Access Compliance Report Public Rights-of-Way (Pedestrian Signals)

Main Street: **HAZARD_AVE** Cross Street: **NEWLAND_ST** Location: **SE**

ADA ID: **SGRK210929114602** Signal Type: **One Push Button-Non APS** Overall Compliance: **No** Severity Scores: **BTN 1: 35** **BTN 2: N/A** **No BTN: N/A**

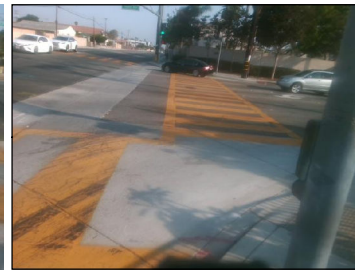
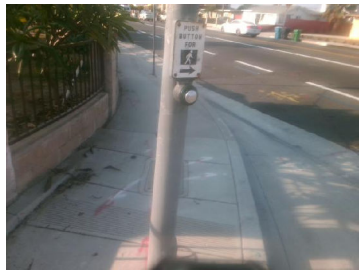
Possible Solutions: Replace Signal Push Button With APS Button. Remove and Replace Clear Space.

OC Std/PROW: **R404.2, MUTCD 4e.08**
